Access Compliance Report Public Rights-of-Way (Curb Ramps)

Main Street: DEAN_ST Cross Street: MELVIN_WAY Location: NW

ADA ID: RPRK220103151423 Ramp Type: Type 1 - Perpendicular Diagonal Initial Pass/Fail: Fail Overall Compliance: No Severity Score: 15

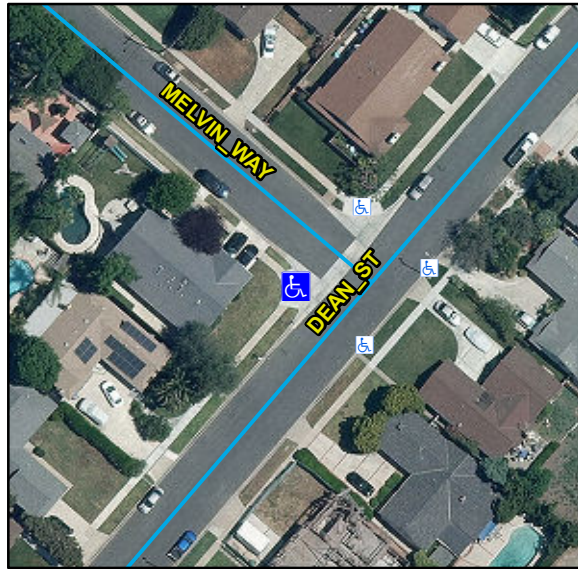
Surveyor Notes:

N/A

Remove & Replace Curb Ramp With Two New Directional Ramps or Equivalent.

R304.2.2, STD 1115
